RESPONSE TO USEPA ANDNJDEPCOMMENTS DATED MARCH 9, 2021 ON THE
DRAFT RESPONSE TO AGENCY COMMENTS ON THE DRAFT 2019 GROUNDWATER COMPONENT ANNUAL REPORT
AMERICAN CYANAMID SUPERFUND SITE
BRIDGEWATER TOWNSHIP, NJ

RESPONSE TO USEPA AND NJDEP COMMENTS DATED NOVEMBER 16, 2020 ON
DRAFT 2019 GROUNDWATER COMPONENT ANNUAL REPORT
AMERICAN CYANAMID SUPERFUND SITE
BRIDGEWATER TOWNSHIP, NJ

Figure RTC-1 – Hantush-Bierschenk Plot for OBE-11

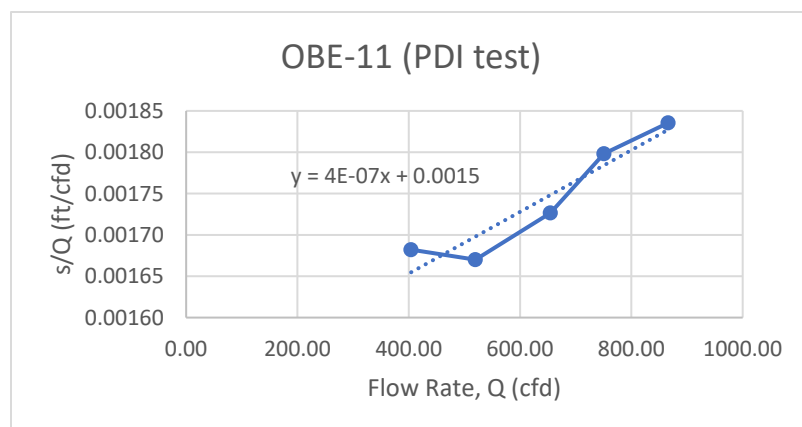
As depicted in Figure RTC-1, the y-intercept (B) is estimated as 1.5E-03 ft/cfd. The slope of the line (C) is estimated as 3.73E-07. The B and C coefficients were then substituted into the general well efficiency equation to yield estimated well efficiencies for each flow rate ranging from 83 to 91% (Table RTC-2). As the actual well flow rate (8.6 gpm) during the July 2019 synoptic was greater than the range of testing (maximum of 4.5 gpm), a well efficiency of 0.50 was conservatively estimated in this instance. In another example, OBE-05 in July 2019 was pumping at a rate of 2.4 gpm, which corresponded to a well efficiency of 58% based on the PDI step testing as shown in Table RTC-2. Tables RTC-2 and RTC-3 summarize the results of the PDI testing, and the December
